**TOWN OF HILTON HEAD ISLAND
THE DESIGN REVIEW BOARD**

AGENDA

Tuesday, April 13, 2010

PROJECT	Edgewater Pool	DRB#	DR100017				
DATE	4/13/2010	RECOMMEND APPROVE	<input type="checkbox"/>	RECOMMEND APPROVE W/COND.	<input checked="" type="checkbox"/> X	RECOMMEND DENY	<input type="checkbox"/>

★ Edgewater
Fence Style

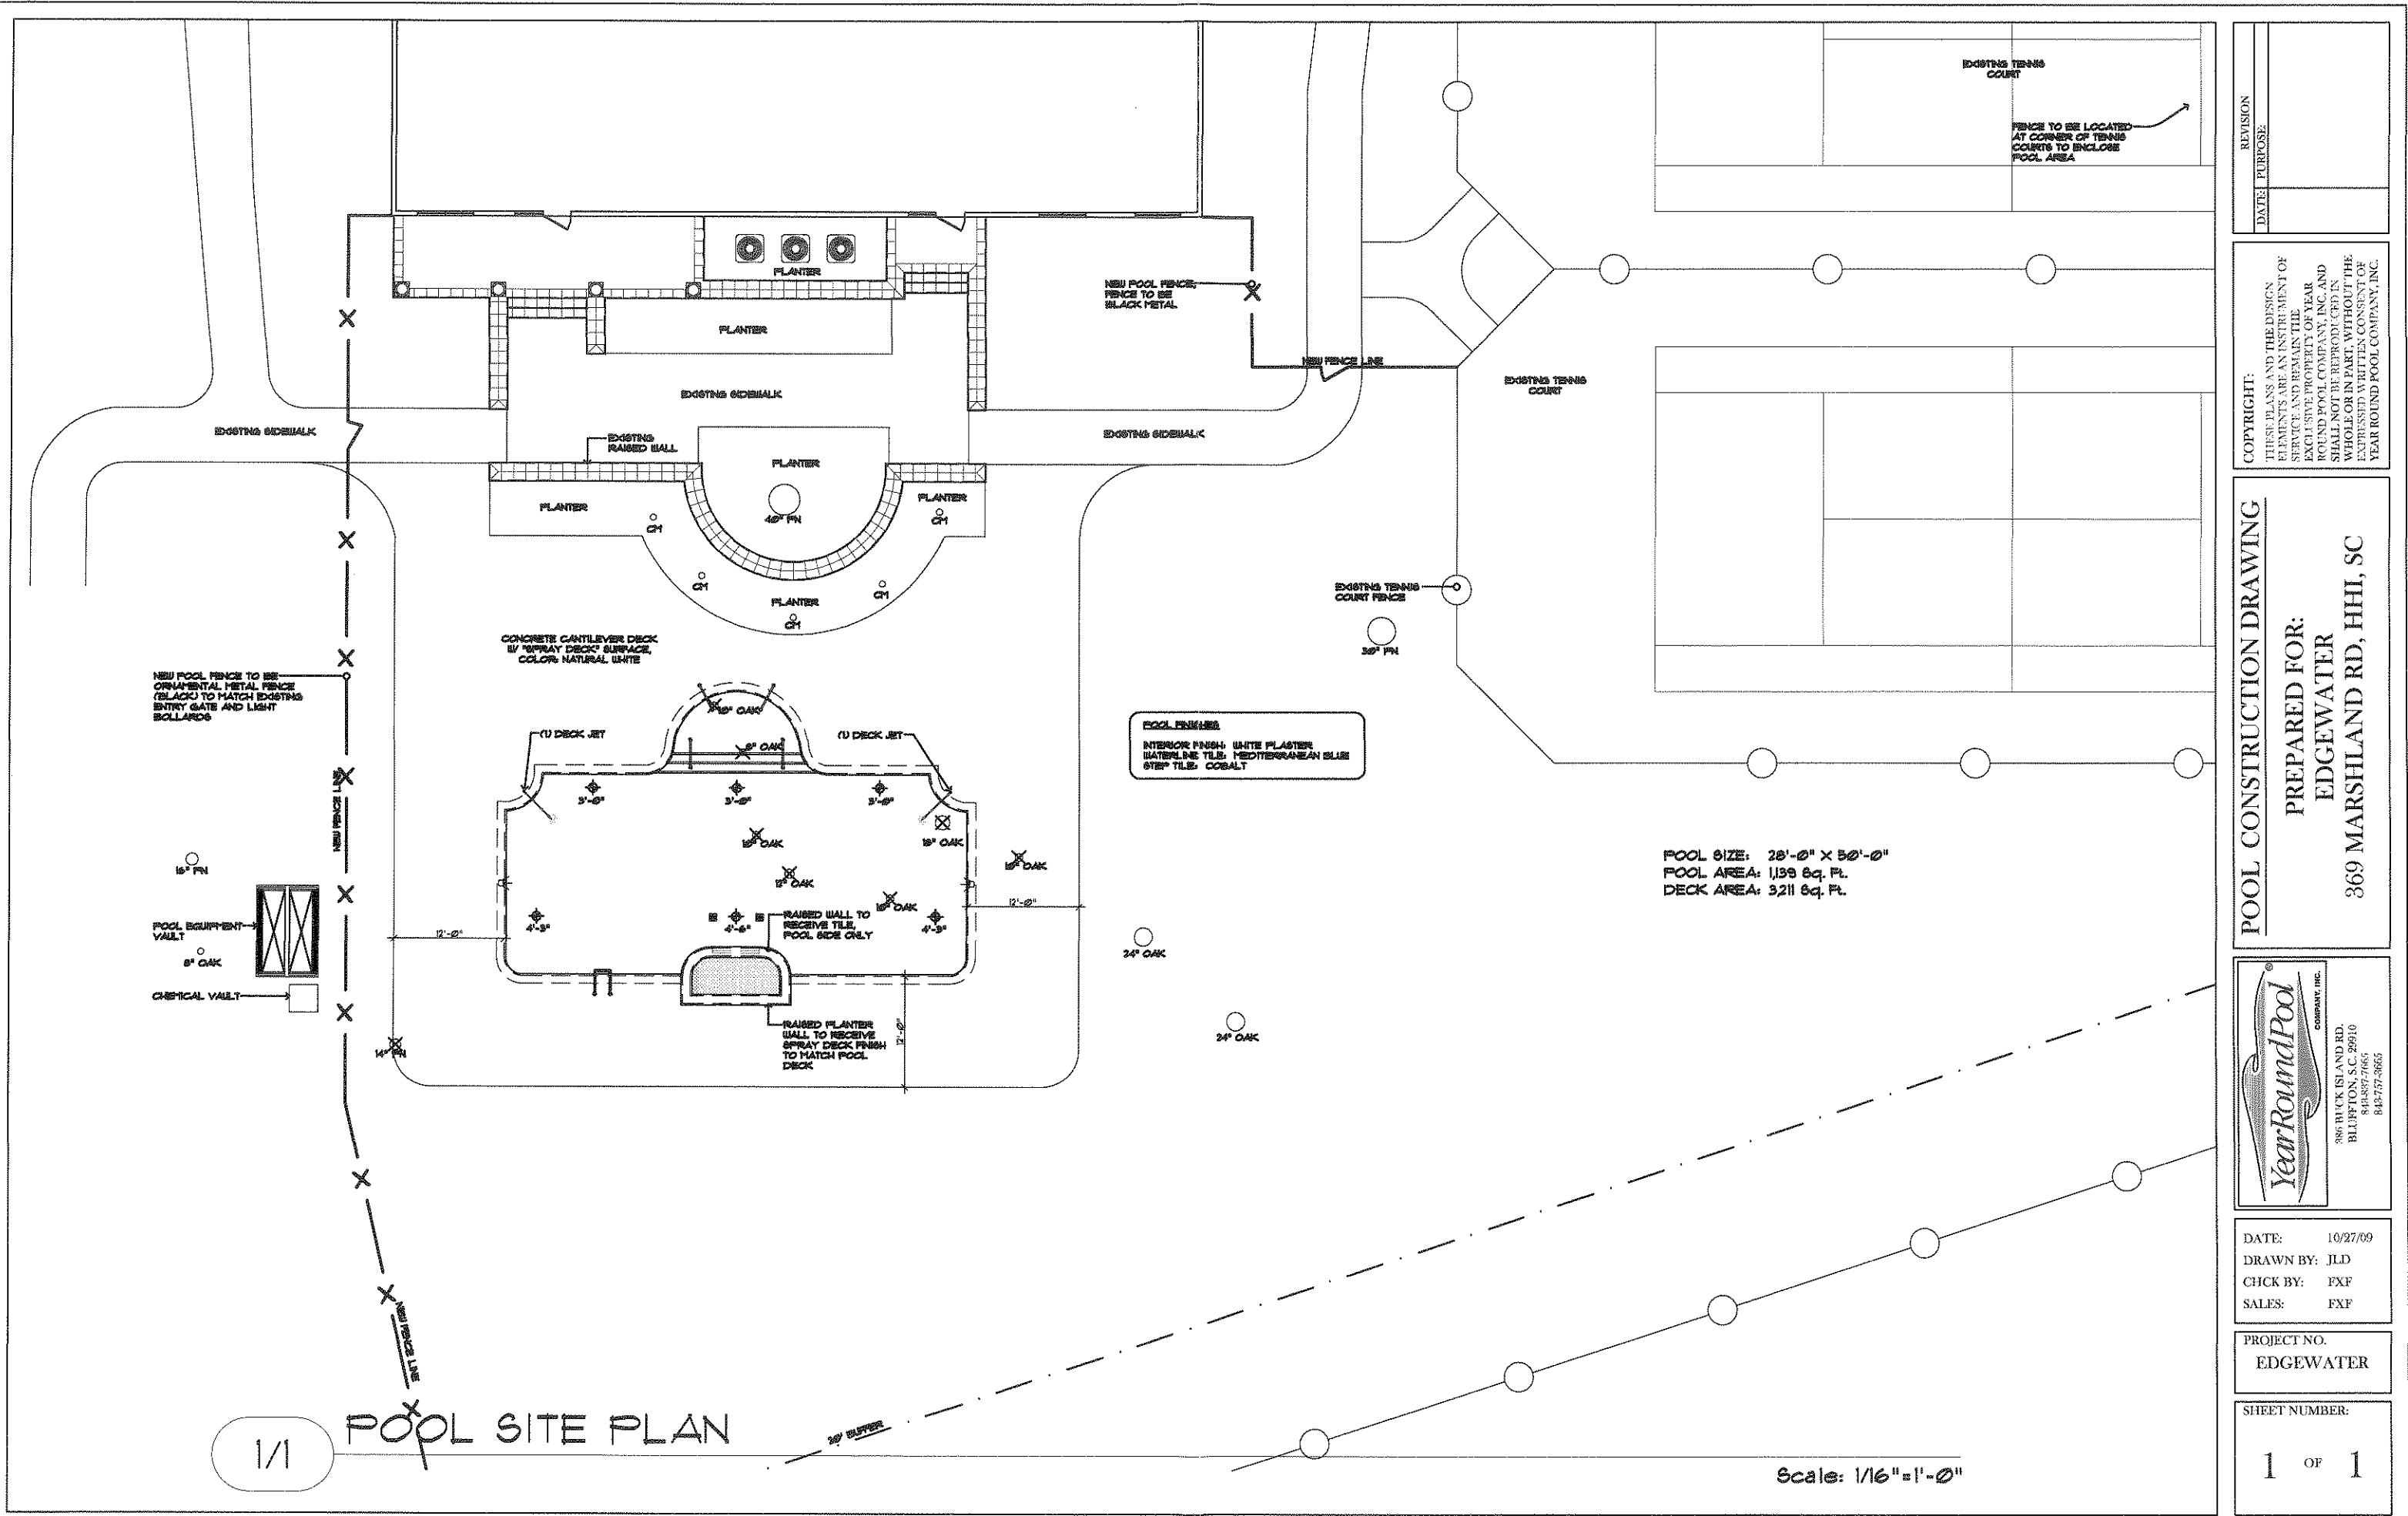
- No detail on the vaults
- No cut sheet on fence, but is to match existing
- Plan would seem to indicate a formal coping but no material is given
- No height or detail provided on planter wall
- Finish on planter wall should match finish on existing planter and building- not white
- Wall cap on new planter should match existing (brick)
- Proposed decking finish could tone down in keeping with the building finishes and still keep surface heat down. Pure white is a little discordant with the design guide
- Symmetrical pool doesn't align with the symmetrical planter, although it does with the existing sidewalk by the building. While disorienting in plan view, it does save a large oak, which is in keeping with the Design Guide
